BROWNS FERRY NUCLEAR PLANT (BFN) - RESPONSE TO NRC INSPECTION 50-259/87-36,
50-260/87-36, and 50-296/87-36

The purpose of this letter is to transmit BFN's response to Inspection Report 87-36 conducted at Browns Ferry during October 1987 on the Design Baseline and Verification Program (DBVP). The inspection report which was issued January 21, 1988 contained no audit findings; however, it did identify weaknesses in the program. TVA has reviewed the inspection report and has responded to each weakness. Please note that certain items identified by the inspection team were already being addressed by TVA, as they had been previously identified by an independent Engineering Assurance Oversight Review Team (EA ORT).

FIGURE 5.2-13

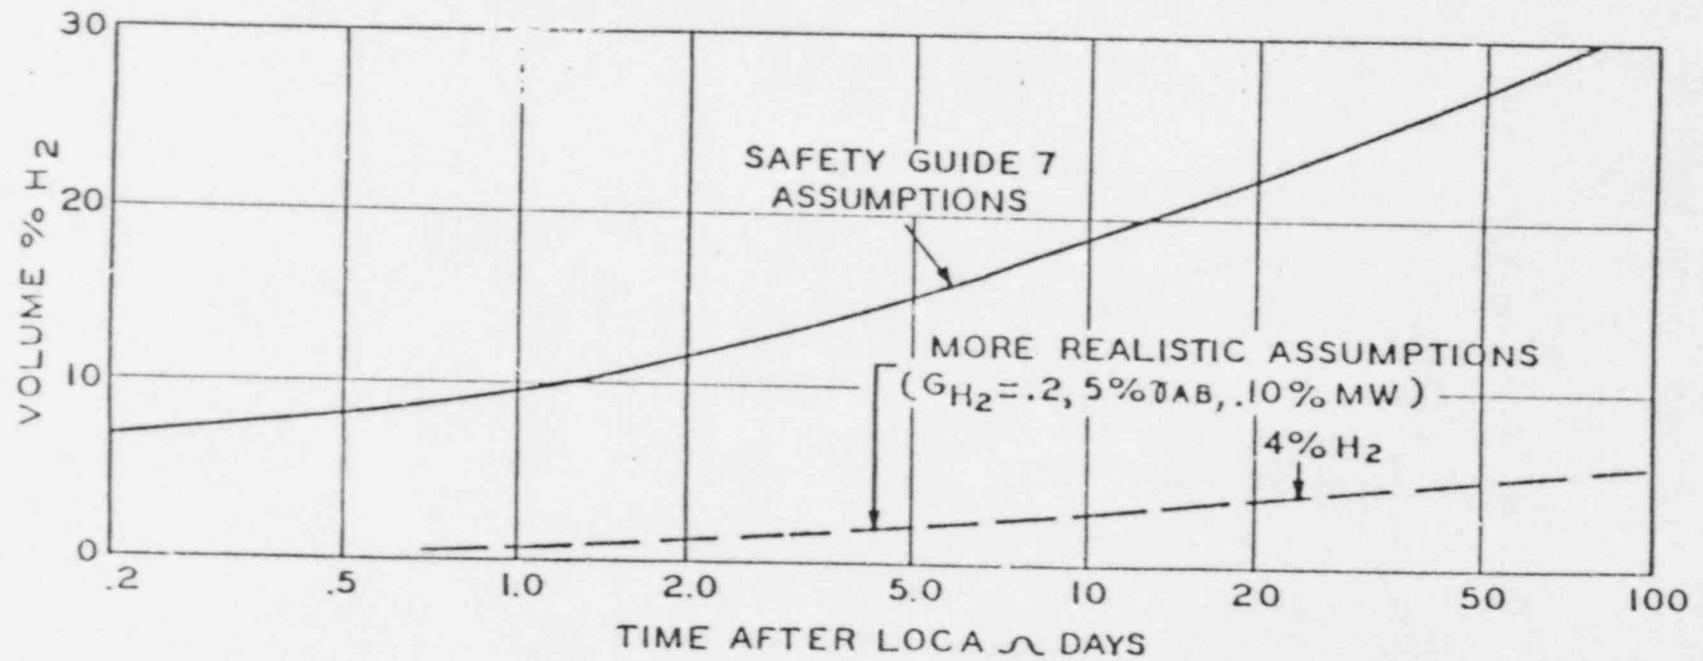
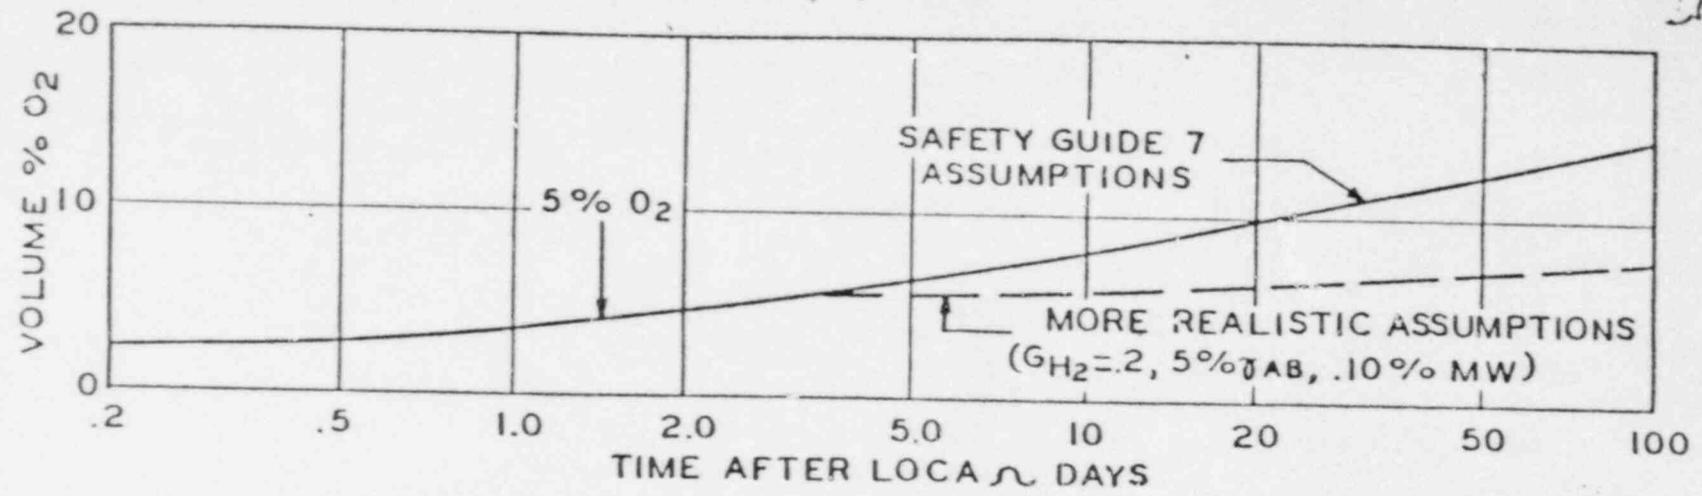
The Systems Mode Requirements for the DBVP Restart Plan identifies various events and actions defined in the Safety Shutdown Analysis (SSA). The review of this document revealed that the containment purge valve (CPV) operational capability is assigned as a Phase 2 priority item. The CPV should be assigned as a Phase 1 priority item.

Safety Guide 7 requires assumptions be made for H₂ and O₂ generation rates following a design basis LOCA. The curves associated with these rates are presented in figure 5.2-13 in the FSAR and shown in attachment 1. However, a more realistic analysis made during the time of licensing shows a lesser rate of H₂ and O₂ generation (see attachment 1). In addition to the H₂ and O₂ generation rates being conservative, once nitrogen was added to the containment for reducing the concentration, a zero percent leakage was applied to the containment atmosphere. However, the actual leakage from containment at BFN can be up to 2 percent of free volume per day and meet its own licensing basis (see section 5.2.5.1 of FSAR). This analysis in the FSAR during licensing pointed out the extra conservatism for the mode of operation.

Using the results of this analysis in conjunction with the licensing basis for BFN and the knowledge that the containment actually does leak, the DBVP analysis of the mode for CAD containment venting was deferred to post restart. The rationale being that the containment vent valves would not be required to open and any pressure build-up in the containment would be depressurized through the containment leakage path into the Stand-by Gas Treatment System. Therefore, the containment vent mode is considered post restart.
